STATE OF VERMONT
AGENCY OF TRANSPORTATION

PROPOSED IMPROVEMENT
CITY OF BURLINGTON AND TOWN OF COLCHESTER
COUNTY OF CHITTENDEN

RECORD PLANS

DIRECTOR OF PROJECT DEVELOPMENT
APPROVED _____ DATE 11/6/03
PROJECT MANAGER :
PROJECT NAME : **Burlington – Colchester**
PROJECT NUMBER : **STP Bike (45)**
SHEET 1 OF 87 SHEETS

BRIDGE FLOOR FRAMING PLAN

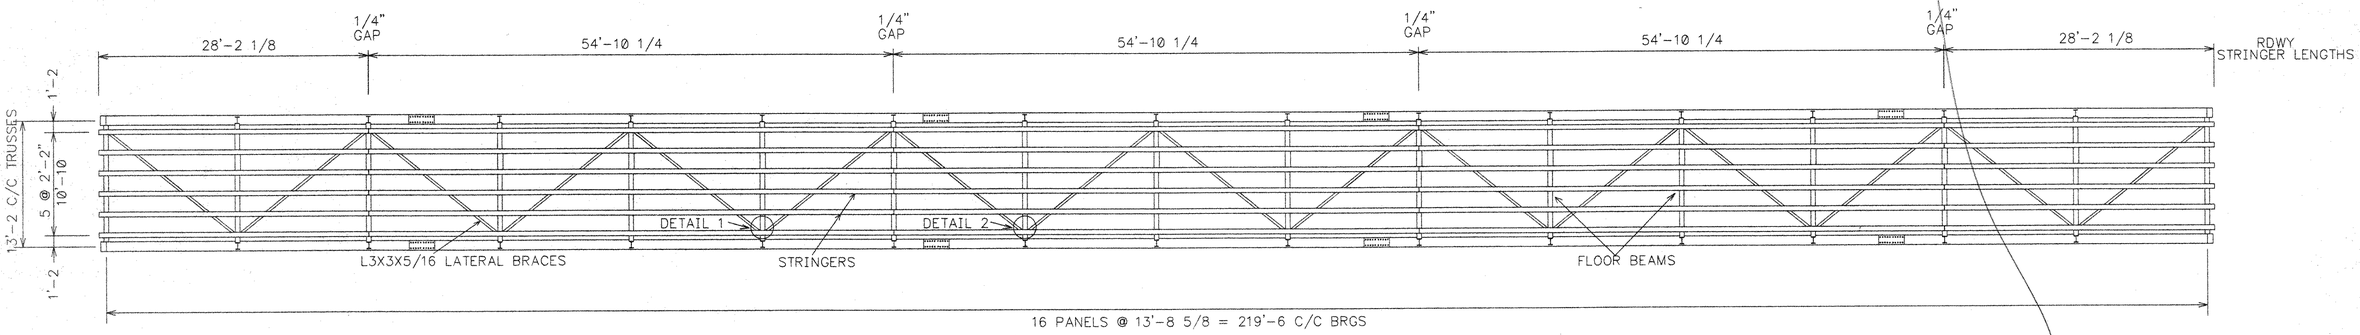
per plans. rail height from 8+50 to 8+77 is 6'-0" see sheet 56 of 87. revise details to reflect this.
